BRITISH GLIDING ASSOCIATION

BGA TECHNICAL COMMITTEE

TECHNICAL NEWSHEET TNS 7/8/91

# GROB G. 102 / ASTIRS.

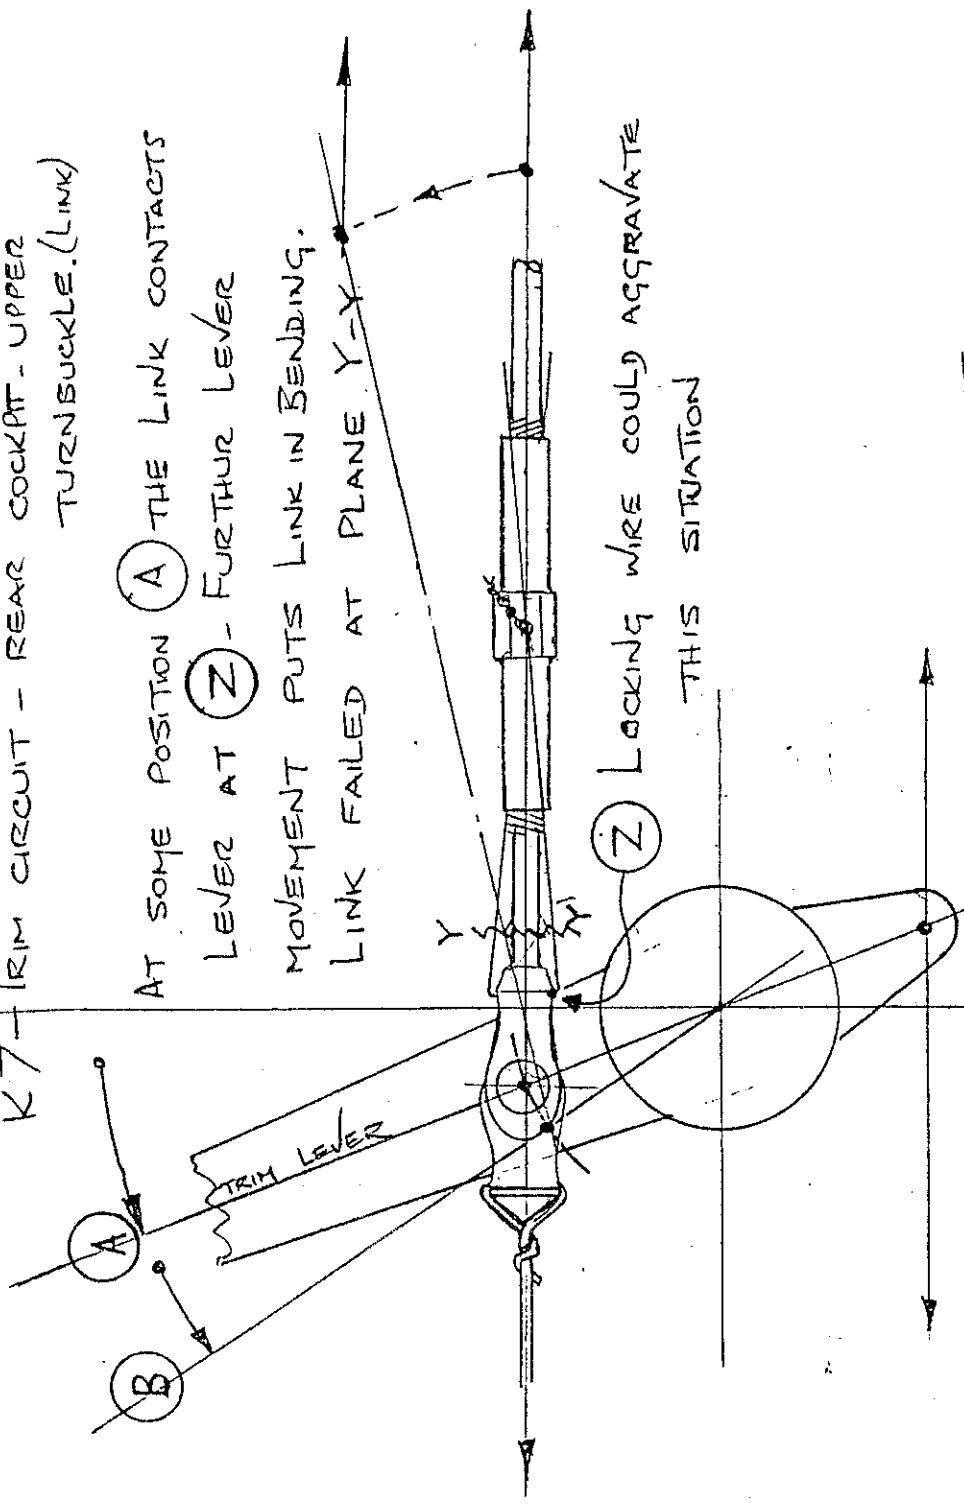
Service Bulletin TM 306-27/1	GROB ASTIR CS ASTIR II
This Service Bulletin substitutes the Service Bulletin TM 306-27 dated 13 Sept 1989.		
Subject:	Inspection of all elevator hinges	
Concerning:	ASTIR CS s/n 1001 - 1536 ASTIR CS 77 s/n 1601 - 1844 ASTIR CS Jeans s/n 2001 - 2248 Club Astir II as of s/n 5001C Standard Astir II as of s/n 5001S G 102 Club Astir III as of s/n 5501C G 102 Club Astir IIIb as of s/n 5501Cb G 102 Standard Astir III as of s/n 5502S	
Urgency:	before next flight	
Procedure:	During operation of the above gliders parting of the inner elevator hinges has occurred on occasion, caused mainly by improper handling during preflight check.	
Actions:	For precaution all elevator hinges, either on the horizontal tail or on the elevator, are to be checked for delamination. Especially attention should be paid for hairline cracks and small buckles around the hinges. Any defect has to be repaired before the next flight, according to Repair Instruction No. 306-27/1. Referring to pre-flight inspections in the future, please do never push the elevator over its constructional stop by force.

Material:	The material (encl. Repair Instruction) can be obtained from the manufacturer on inquiry.	
Weight and balance:	Negligible	
Remarks:	The work must be carried out by a competent person or an authorized aviation work-shop and has to be certified in the logbook by an authorized inspector.	
Mattsies, 04 June 1991	<u>LBA approved</u> The German original of this modification information has been approved by the LBA on the 14 June 1991 and is signed by Mr. A. Skov. The translation has been accomplished to our best knowledge and judgement. In case of doubt, the German original is authoritative.	
 Dipl. Ing. J. Altmann (Airworthiness engineer Certification staff)		
Note:	If in the meantime you have sold your glider, we would ask that you kindly pass this information immediately to the new owner and forward his address and aircraft s/n to us.	
DATUM / DATE 04 June 1991	ERSETZT AUSGABE / ISSUE EDITION	BEARBEITET / PREPARED BY R. Vodermeier

VENTUS TURBO SERIAL No 35

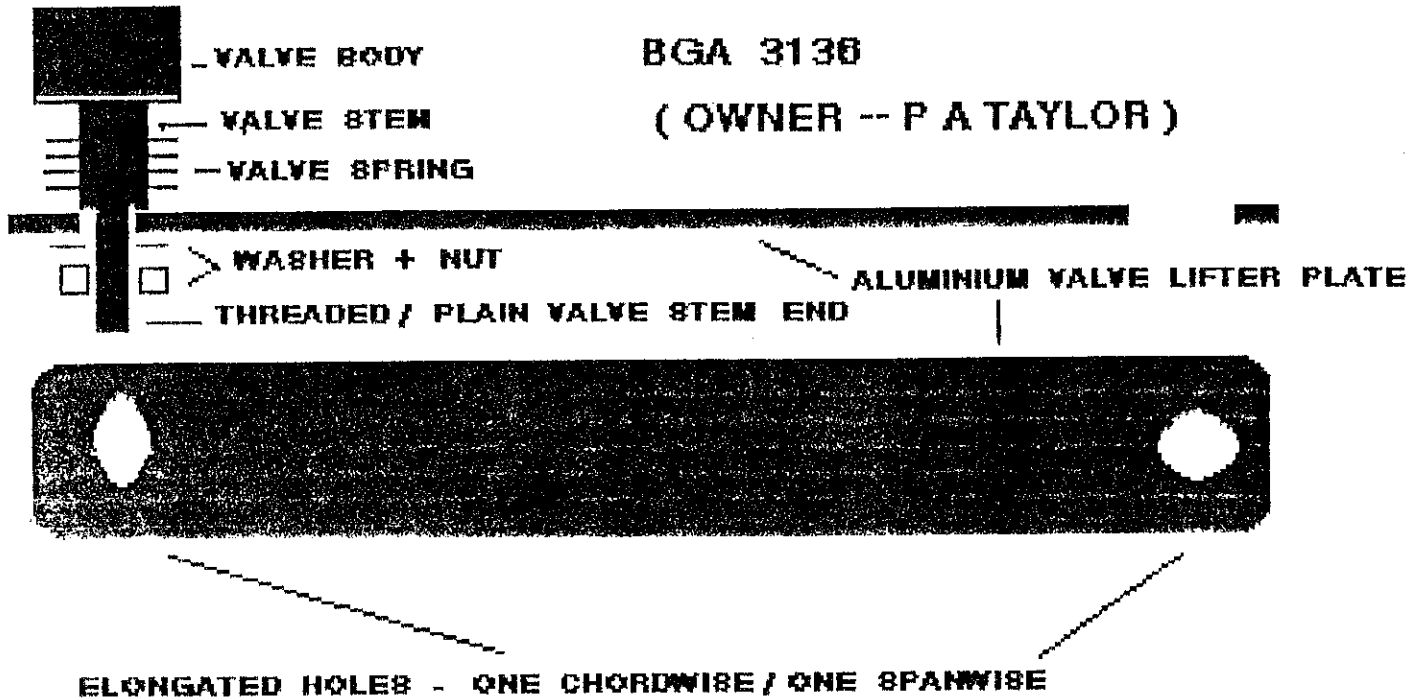
FOLLOWING FAILURE TO START IN AIR DUE TO ENGINE NOT SPINNING UP IN AIRSTREAM INVESTIGATION REVEALED HOLES IN ALUMINIUM VALVE LIFTER PLATE HAD BECOME ENLARGED AND ELONGATED AS PER SKETCH.

THIS HAD ALLOWED ONE OF THE TWO VALVE STEMS TO PASS THROUGH THE PLATE HOLE SUCH THAT ACTIVATION OF THE VALVE LIFTER HANDLE FAILED TO LIFT THAT VALVE.

THE ELONGATION OF THE HOLES WAS UNDOUBTEDLY THE RESULT OF VIBRATION, ONE HOLE IN PARTICULAR WAS SURROUNDED BY A CONSIDERABLE BURR.

THIS PARTICULAR ENGINE HAS RUN FOR A TOTAL OF 31 HOURS IN 873 AIRFRAME HOURS.

I STRONGLY RECOMMEND ALL SOLO ENGINES BE CHECKED AS A MATTER OF URGENCY. COULD THIS HAVE ANY RELEVANCE TO THE RECENT TURBO VENTUS FATALITY? I SUGGEST THE ALUMINIUM PLATE NEEDS REPLACING WITH A STEEL PLATE, OR APPROPRIATELY SIZED STEEL WASHERS BE INTRODUCED ON BOTH SIDES OF THE ALUMINIUM PLATE.
